## Unacceptable telecommunications masts (2) – at the eastern end of Loch Mullardoch on the Glencannich estate

This post takes a look at the recent planning application – there are dozens more to come – for a mast at the eastern end of Loch Mullardoch to highlight some further implications of the Shared Rural Network programme.

SITE PHOTOGRAPH

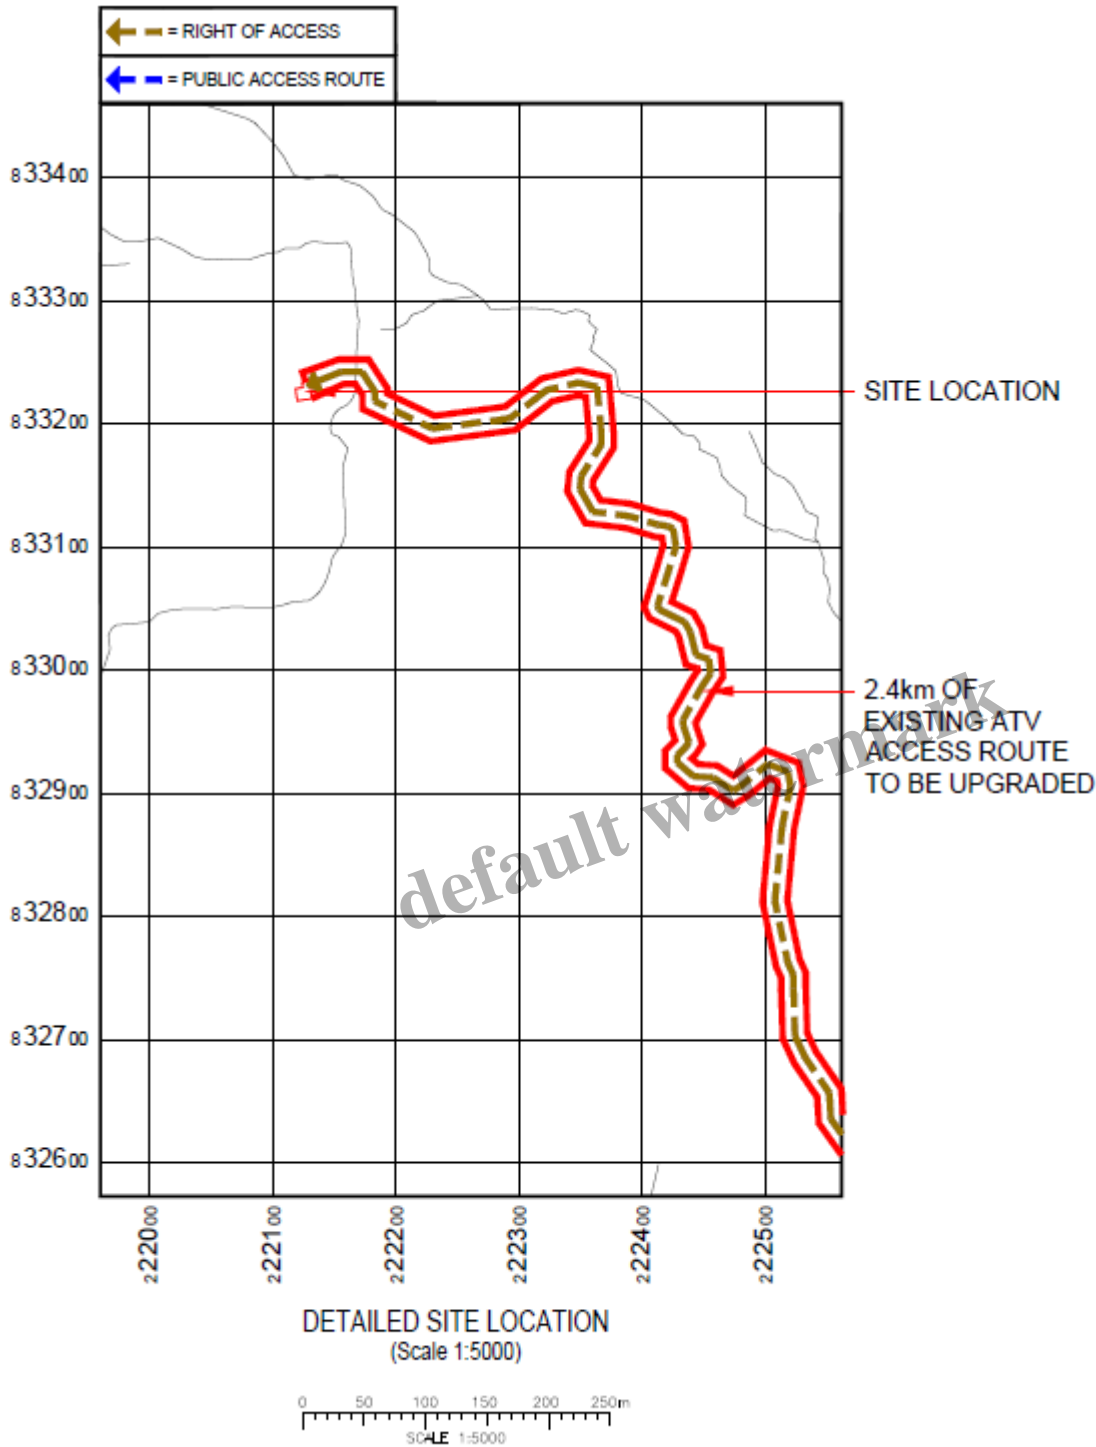
very damaging precedent. The site location is far higher than most applications for mast to date at a height of c650m rather than lower down the side of the glen. Allow this and there could soon be telecommunications masts on some of Scotland's great ridges.

The application contains several vague statements about the importance of the landscape and how the developers are trying to minimise the visual impact of the mast which will be sited on a rocky outcrop more or less opposite the Munro Toll Creagach on the south side of Loch Mullardoch. The developer claims the form of the outcrop will partially screen the mast from view but predictably fails to discuss specific viewpoints (other than from the road). No landscaping is proposed "due to the steep terrain".

Hydro track on left, the very approx position and line of new 2.4km road indicated in red on right.

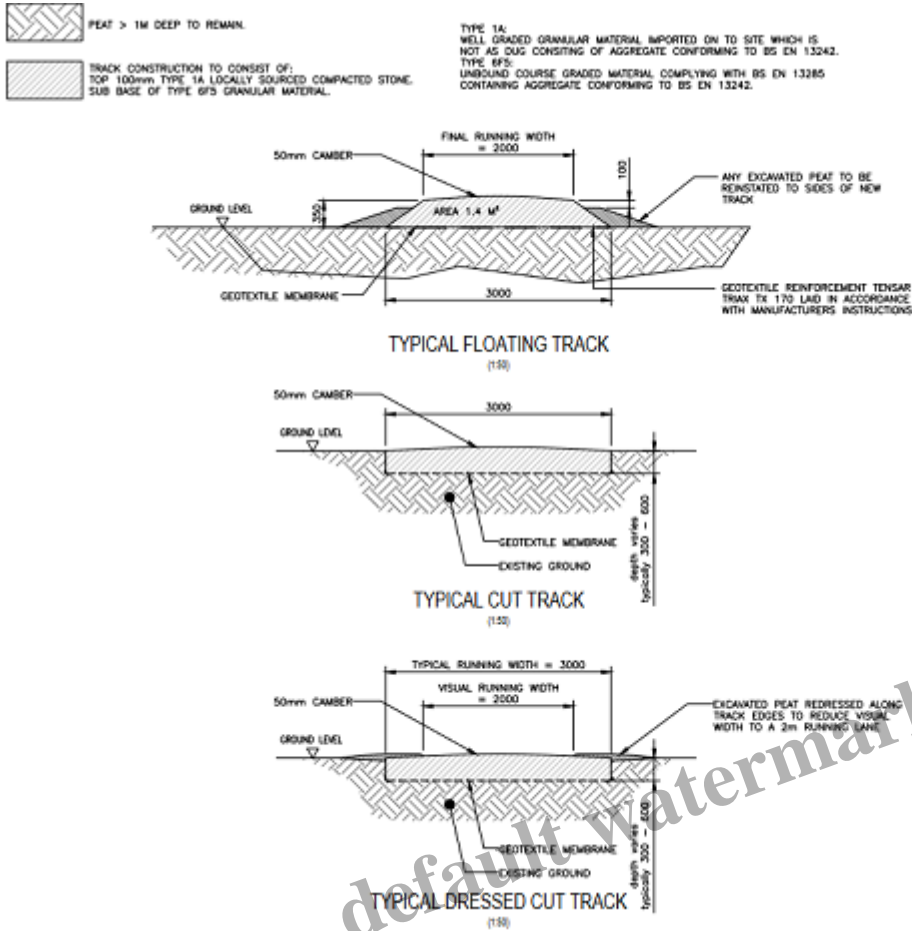
As part of the planning application a new 2.4km road is proposed up to the site of the mast. Again there is no attempt to consider the visual impact of the road – which is justified on the grounds that there is already a track created by ATV use up the hillside – but coupled with the horrible hydro track it will completely trash the last feelings of wildness at the east end of Loch Mullardoch.

Looking carefully at the full size original photo taken in 2019 I could just make out some ATV tracks heading up the hillside but their visual impact is nothing compared to what would be a 3m wide scar up the hillside. The “design” of the proposed road is contained in the “Access Layout” document and is not fit for any purpose:

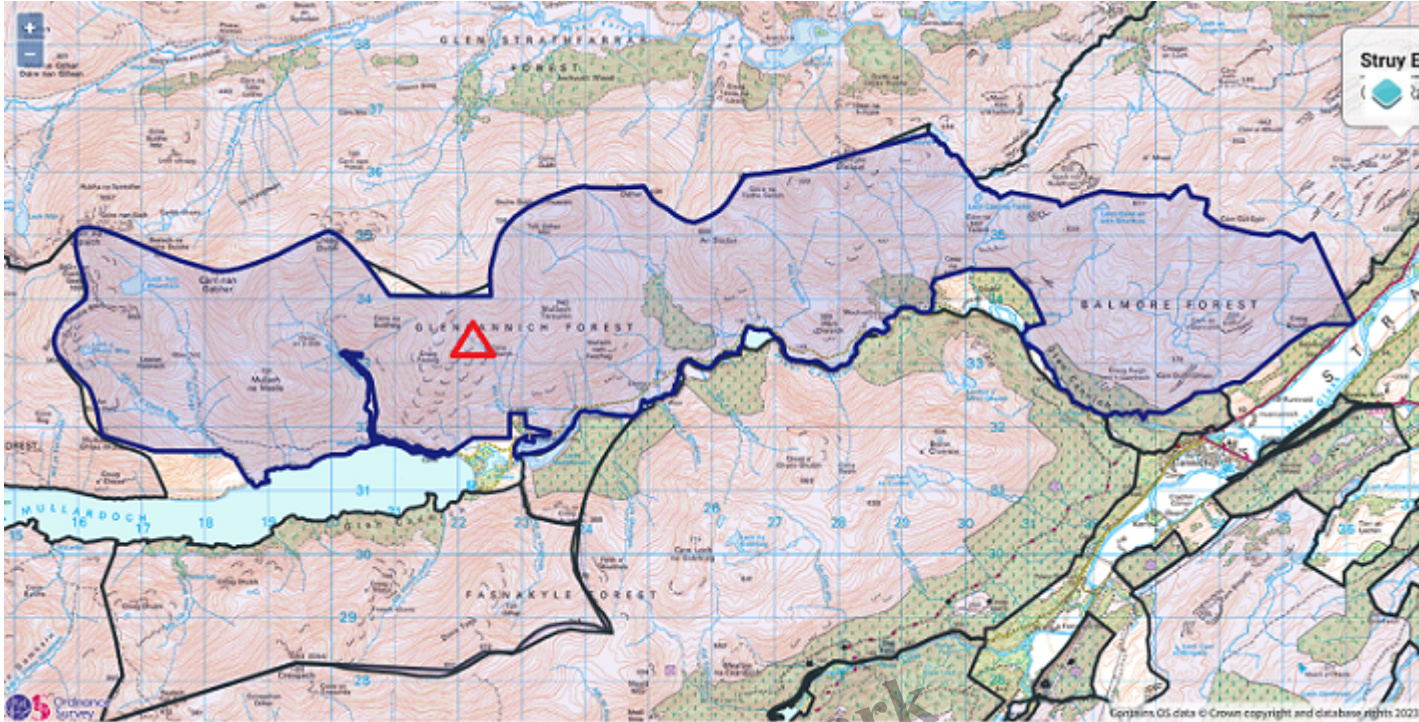
Showing “typical” sections of a road tells you almost nothing, apart from the fact this road will be 3m wide (on the “narrower” straight sections). There has been no survey to show much of the track will float on peat more than 1m thick nor how much peat less than 1m thick will need to be excavated to create the road. Moreover:
